Part 573 Safety Recall Report

22V-484

SUBJECT: NEW VEHICLE DEMONSTRATION / DELIVERY HOLD - Safety Recall 22S47
Certain 2021-2022 Model Year Corsair, 2020-2022 Model Year Escape and 2022
Model Year Maverick Vehicles Equipped with a 2.5L HEV/PHEV Engine
Under Hood Fire

FIGURE 1

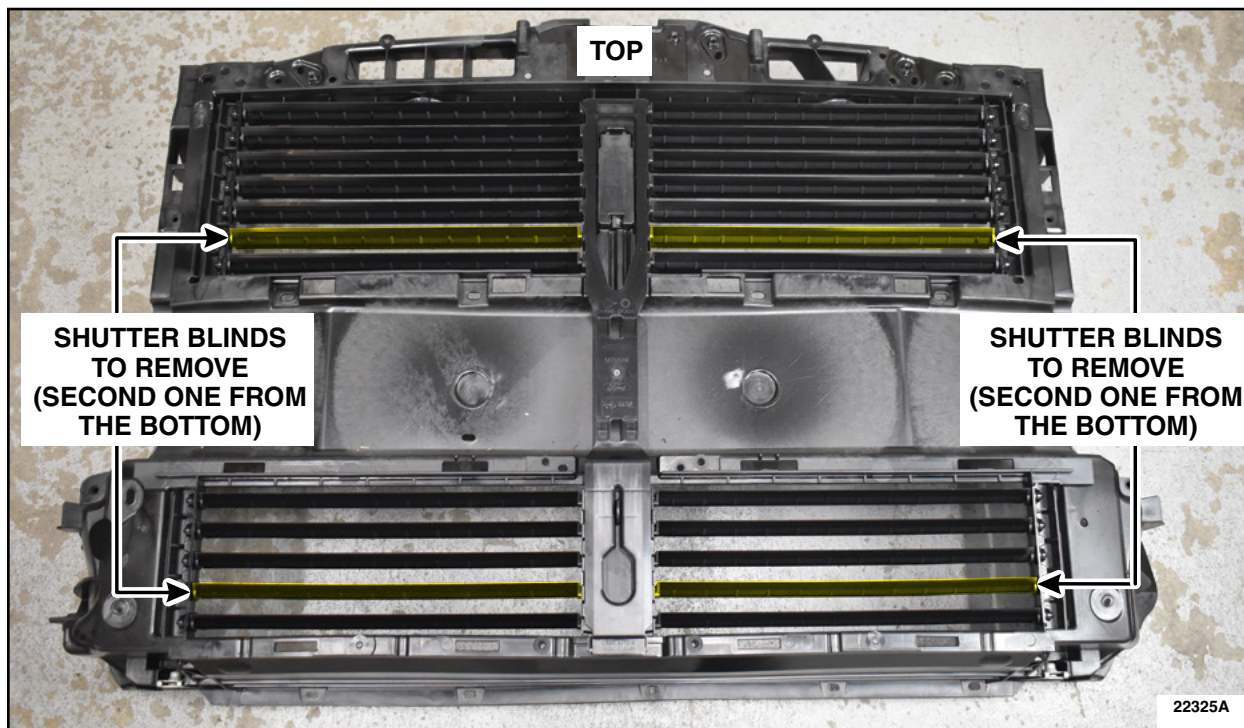
2. Remove the four required shutter blinds. See Figures 1, 2, 3 and 4.

- First, bend the shutter blind at center and pull toward the front of the vehicle, then remove the OUTBOARD side tab from hole in housing.
- Second, pull to dislodge the INBOARD side tabs via pulling toward outboard the side of vehicle and remove the shutter blind.
- Third, verify all remaining shutter blinds move and do not bind.

FIGURE 4

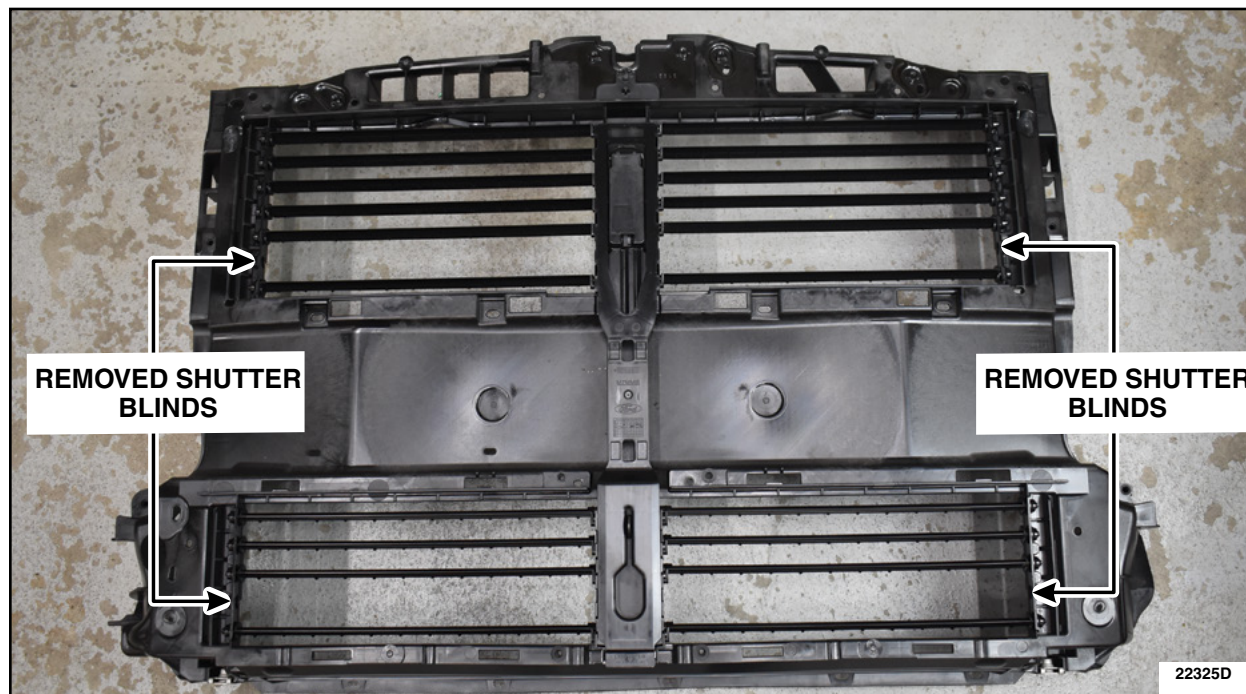
Completed AGS Assembly Modification

FIGURE 5

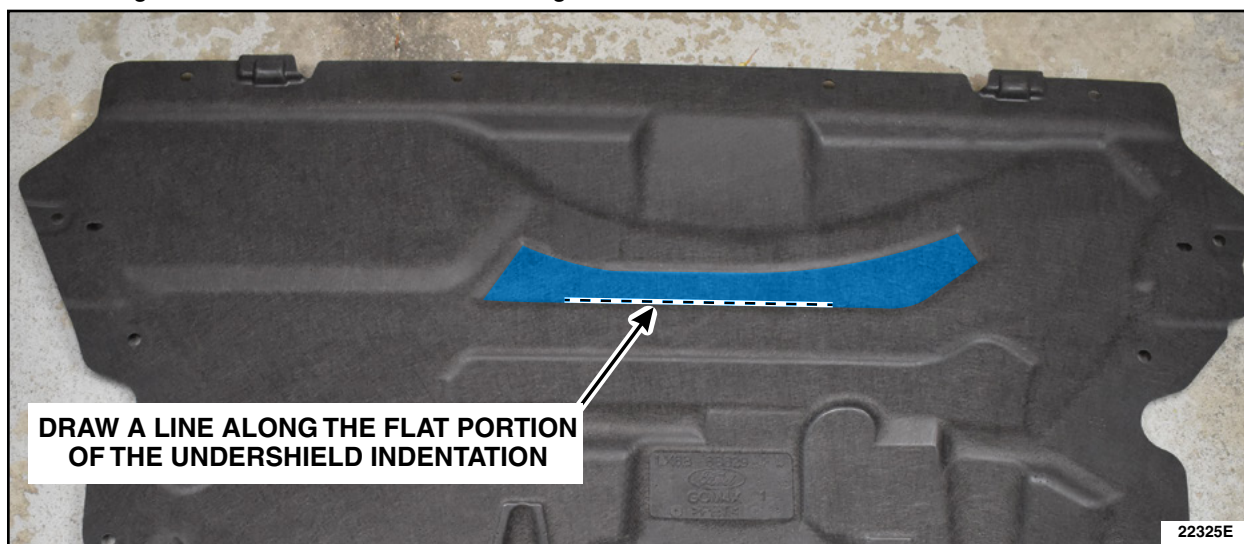
6. Using a liquid paint marker or equivalent, draw a line on the engine front undershield along the flat inner edge of the indentation as shown in Figure 5.

FIGURE 6

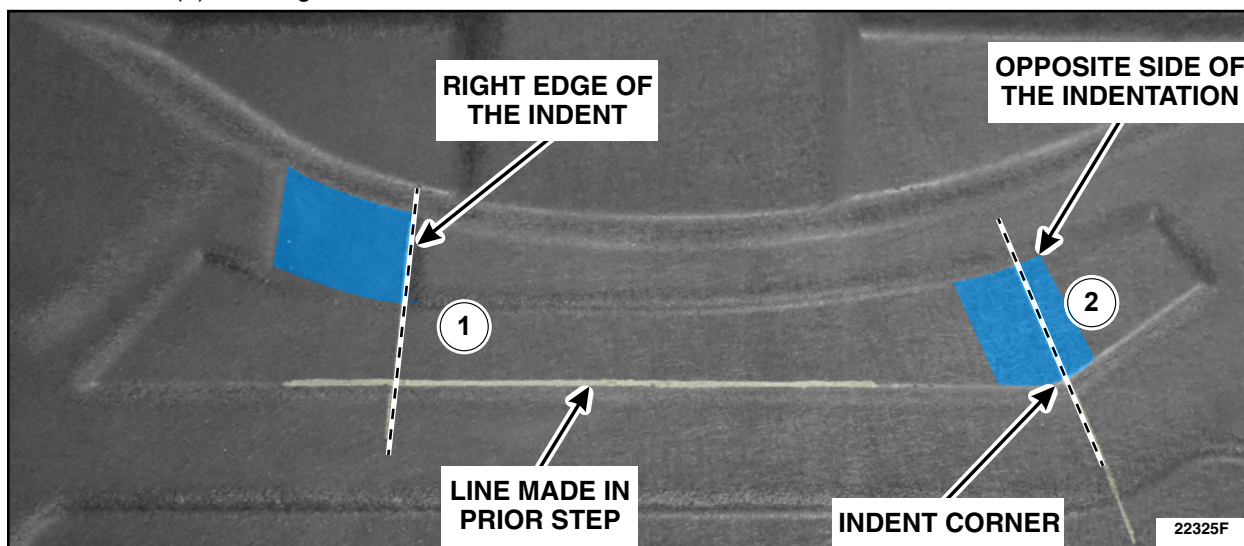
7. Using a liquid paint marker or equivalent and a flat edge, draw a line from the right edge of the indent to the line made in the prior step (1). Draw a line from the indent corner to the opposite side of the indentation (2). See Figure 6.

FIGURE 7

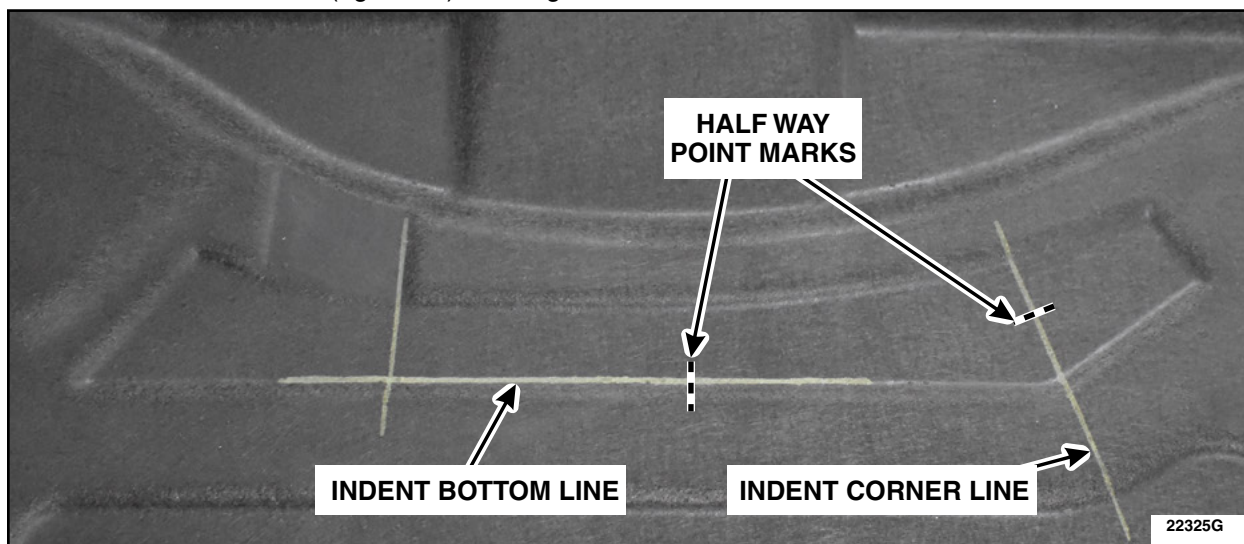
8. Using a liquid paint marker or equivalent, put a mark at the half way point on the indent bottom line and on the indent corner line (right side). See Figure 7.

FIGURE 8

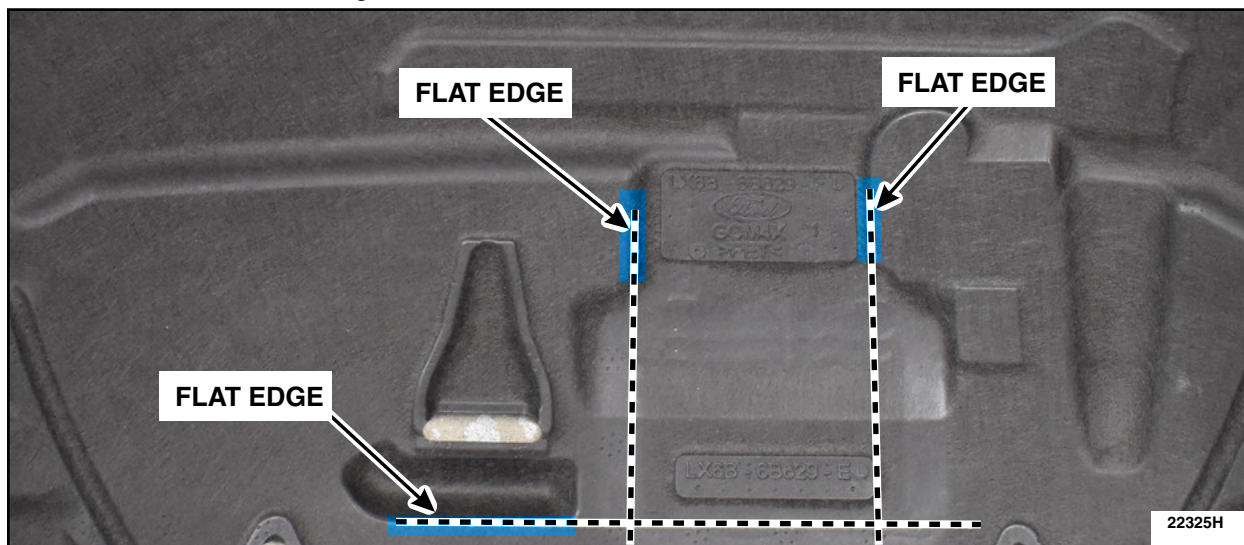
9. Using a liquid paint marker or equivalent and a flat edge, draw 3 lines using the flat side of the indentations shown. See Figure 8.

FIGURE 9

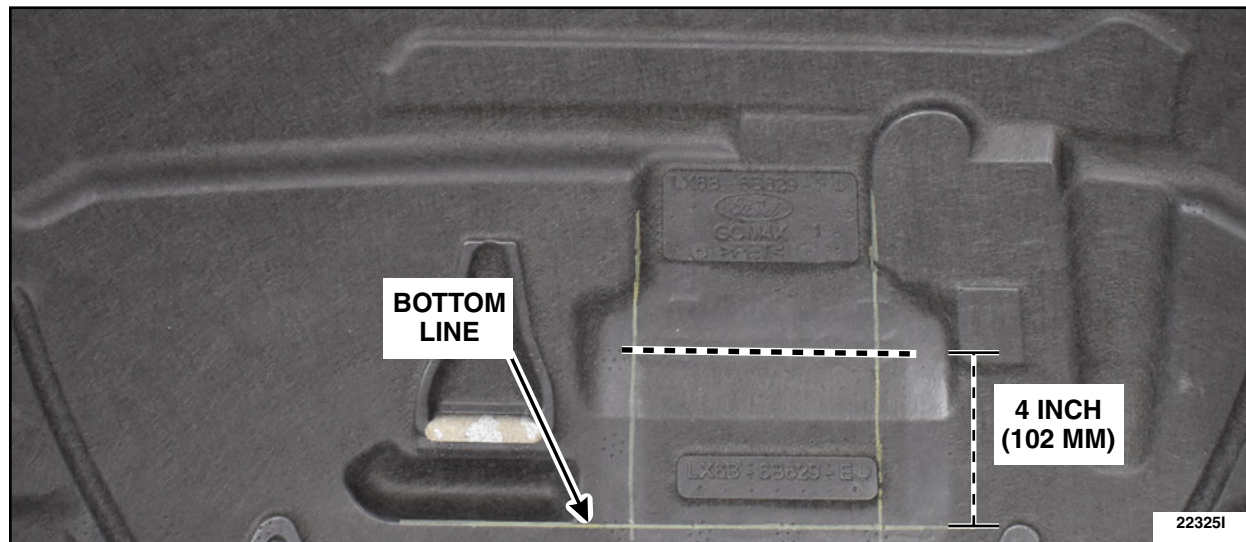
10. Draw a line 4 in (102 mm) up from the bottom line. See Figure 9.

FIGURE 10

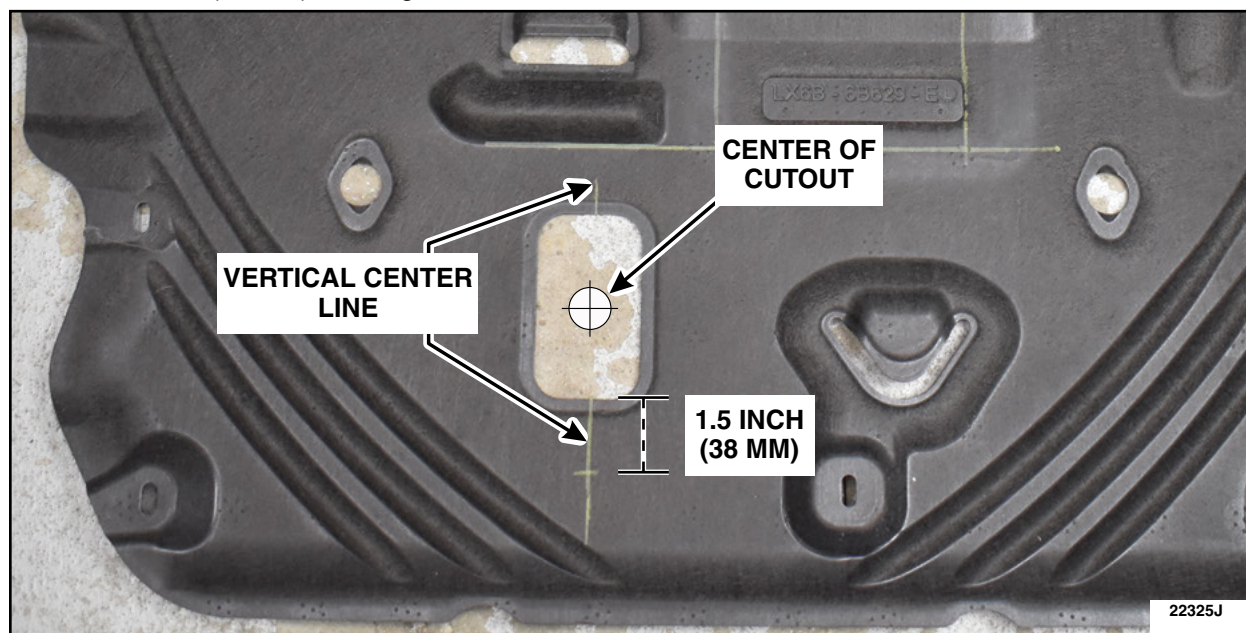
11. Find the center of the cutout and draw a line for vertical center. Measure from the bottom edge of the cut out 1.5 in (38 mm). See Figure 10.

FIGURE 11

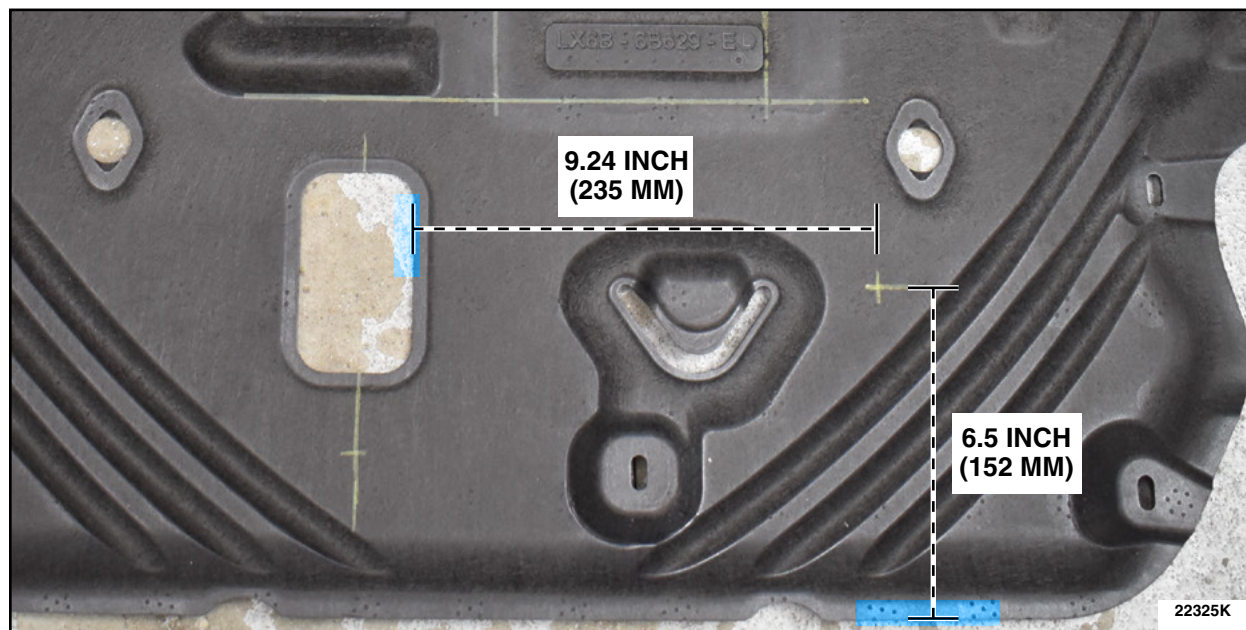
12. Measure 9.25 in (235 mm) from the cut out and 6.5 in (152 mm) from the edge of the shield.
See Figure 11.

FIGURE 12

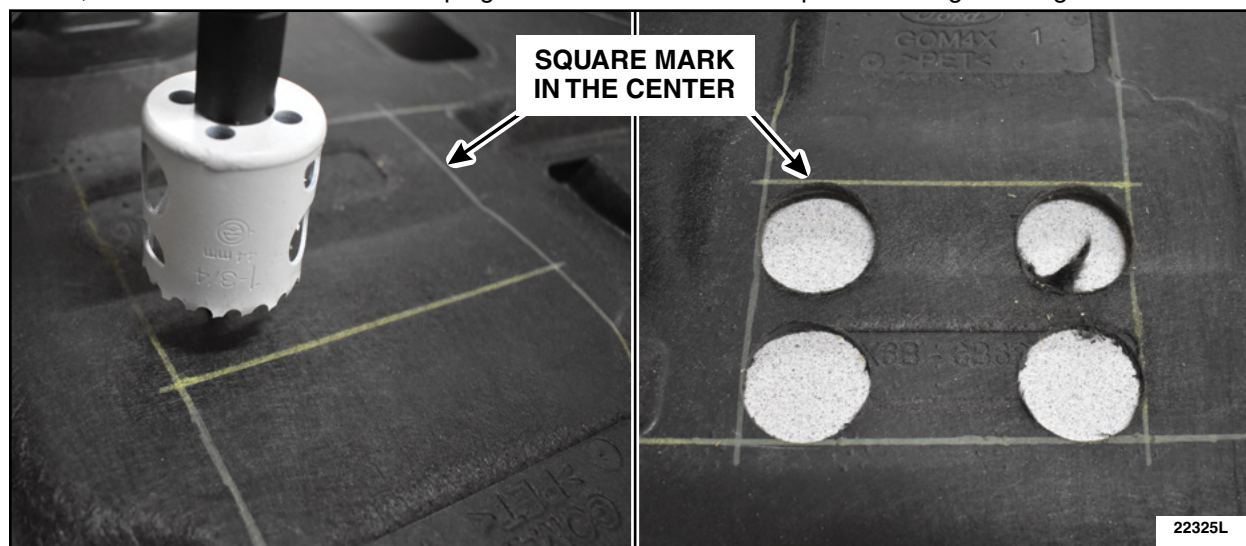
13. On the square mark in the center, using a 1-3/4 inch (44 mm) Bi-Metal Hole Saw with arbor and pilot bit, drill a hole in each corner keeping the hole saw within the square marking. See Figure 12.

FIGURE 13

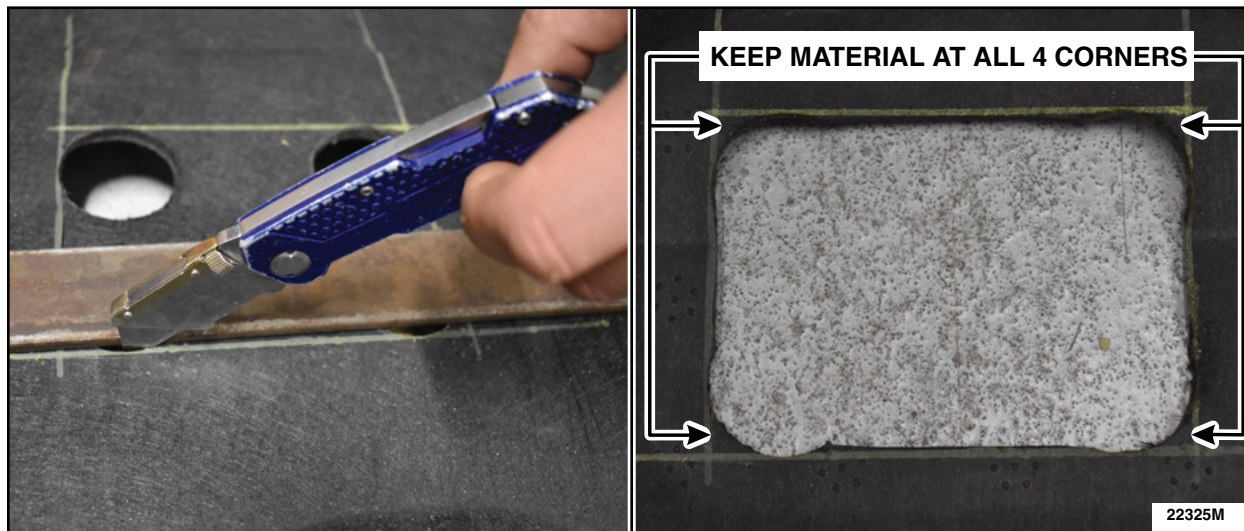
14. Using a straight edge and a utility knife, cut out the underbody shield material left between the 4 holes made within the square. See Figure 13.

FIGURE 14

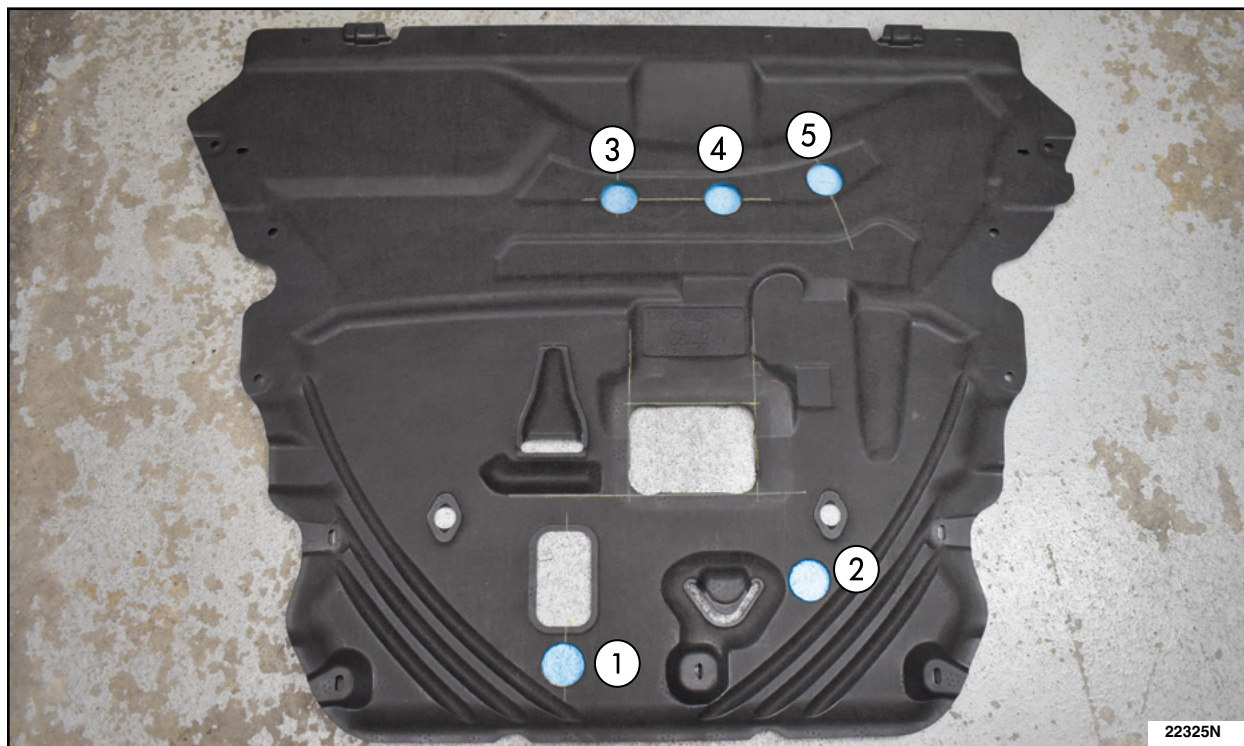
15. Using a 1-3/4 inch (44 mm) Bi-Metal Hole Saw with arbor and pilot bit, drill out the remaining 5 holes. See Figure 14.

FIGURE 15

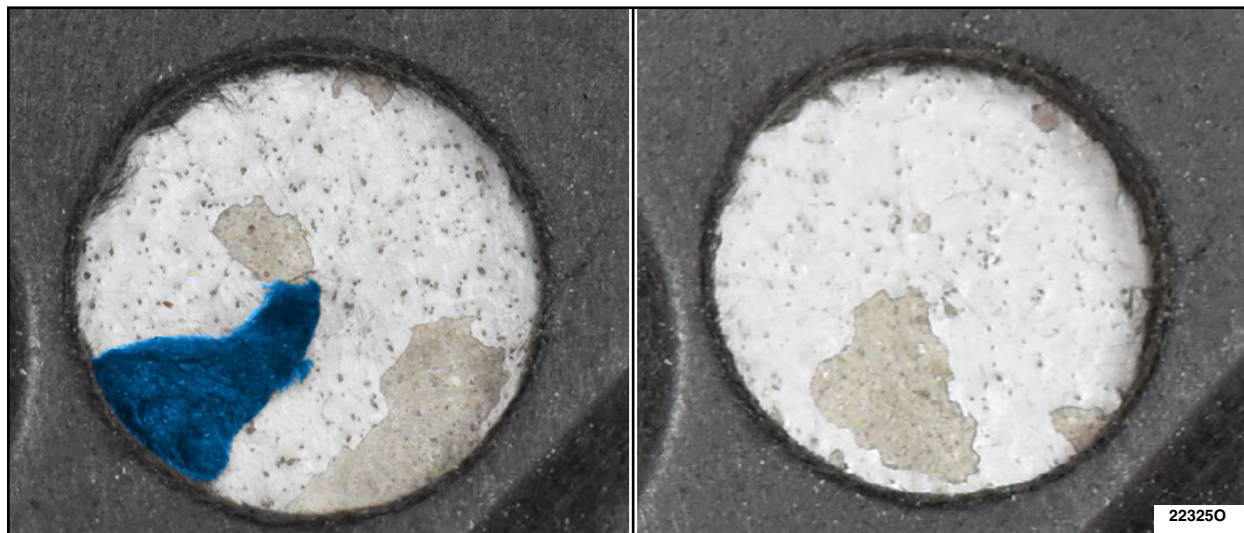
16. Using a utility knife, clean up any burrs and stray pieces of underbody shield material in any holes drilled. See Figure 15.
